M8 Speed Limit Order - Roadstone Drawing 001

M8 Junction 18 Glanmire

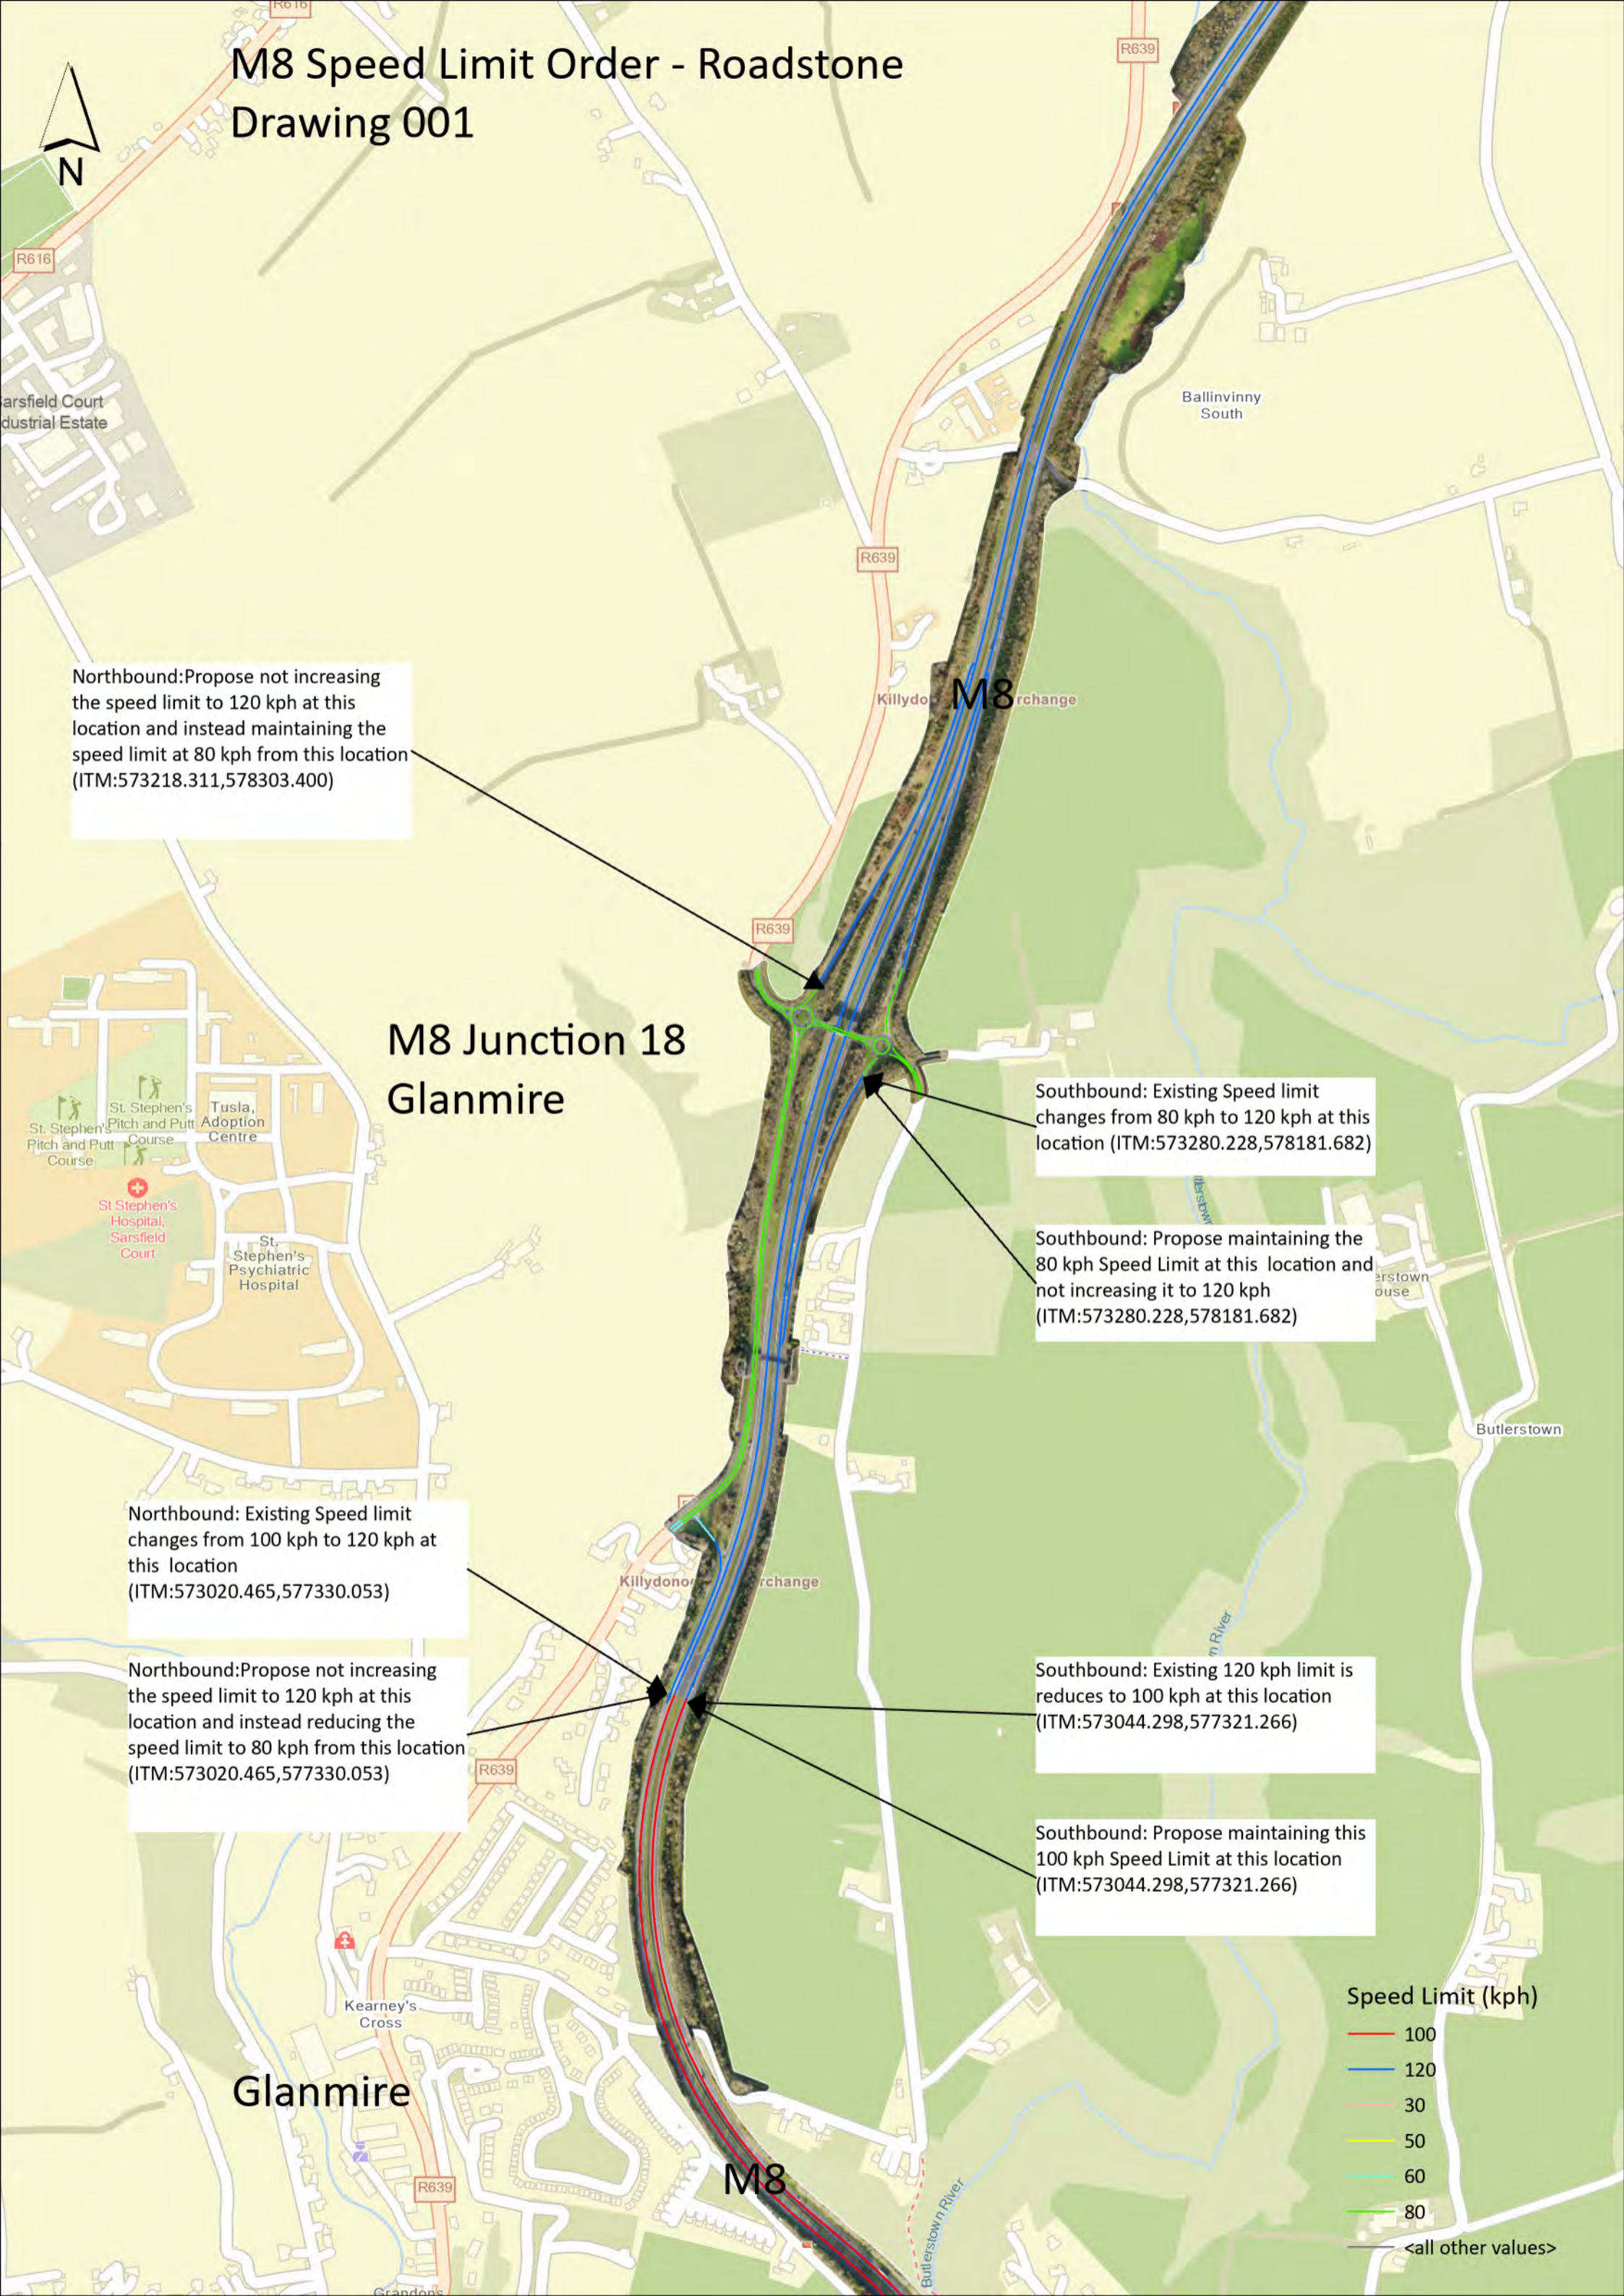
Northbound: Propose not increasing the speed limit to 120 kph at this location and instead maintaining the speed limit at 80 kph from this location (ITM:573218.311,578303.400)

Southbound: Propose maintaining the 80 kph Speed Limit at this location and not increasing it to 120 kph (ITM:573280.228,578181.682)

Northbound: Propose not increasing the speed limit to 120 kph at this location and instead reducing the speed limit to 80 kph from this location (ITM:573020.465,577330.053)

Southbound: Propose maintaining this 100 kph Speed Limit at this location (ITM:573044.298,577321.266)
